September 24, 2020

Re: Appeal of Alamo Manhattan Blocks in South Waterfront
LU 20-102914 DZM GW AD; PC # 19-22572

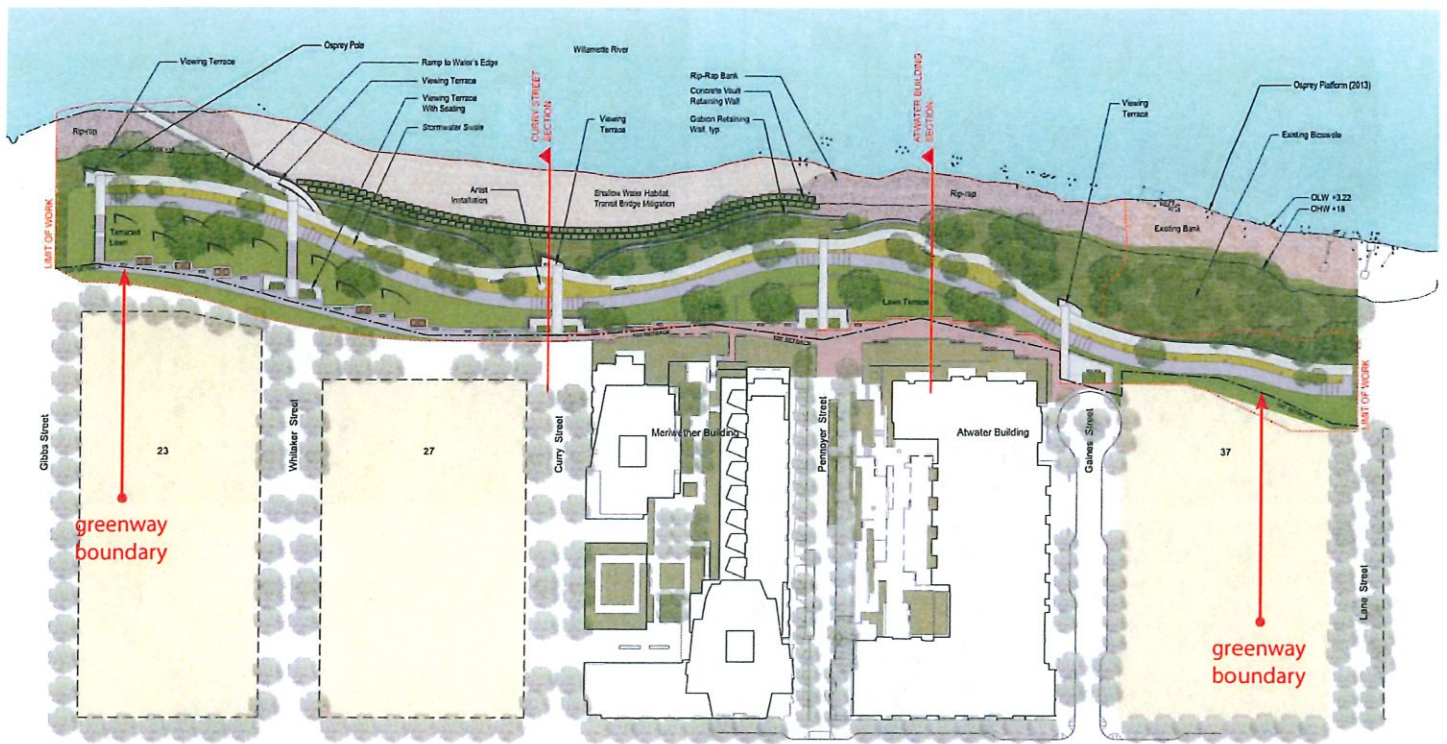
The Council identified significant concerns over the Greenway design - not just the patio at the end of S Lowell but the extent and design of those gathering spaces. Again, the Applicant responded by redesigning only the patio and modest cosmetic improvements on the plaza, that do not address the heart of the deficiency. The Greenway design remains inadequate. Testimony was submitted that Prosper Portland and Portland Parks and Recreation offered additional funds to allow Greenway improvements beyond the minimum standards proposed. Those offers were rebuked. Portland's planning process is directed at collaboration and cooperatively bringing all stakeholders together to meet development goals, protect future residents and promote public good. This developer failed to collaborate or to provide a development that protects the Greenway and provide a sufficient level of public amenities.

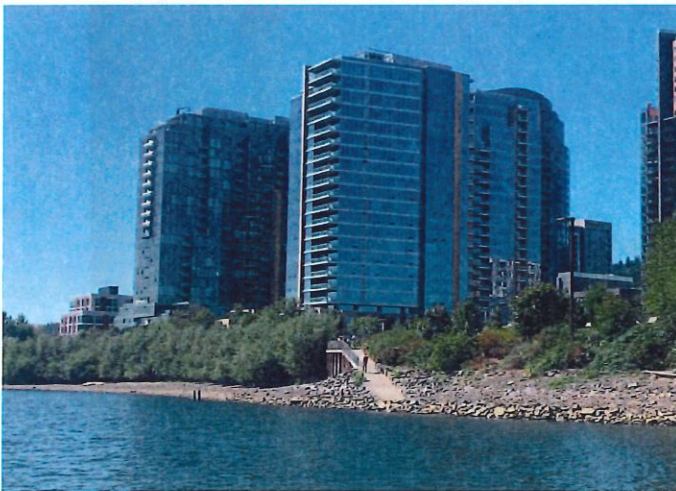
The first South Waterfront buildings “set the tone for the quality of open space in the district.” The greenway is 125-145 feet in width.

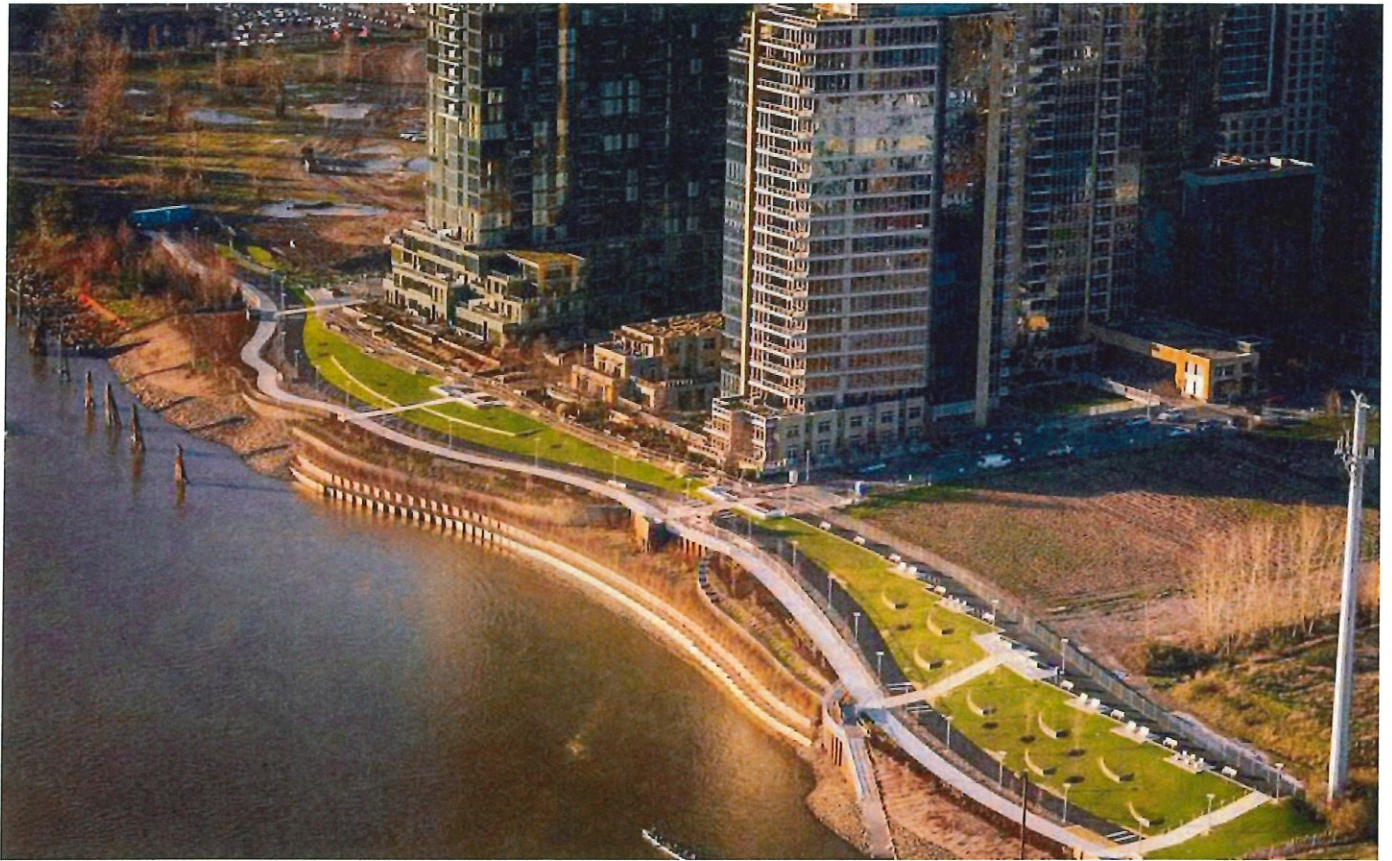
Alamo south corner continues to look like a private use area. This does not appear to welcome casual trail users or to be integrated into the greenway.

The side view is barren and uninviting. The lack of landscaping and stormwater swales is instark contrast to the rest of South Waterfront (see below).
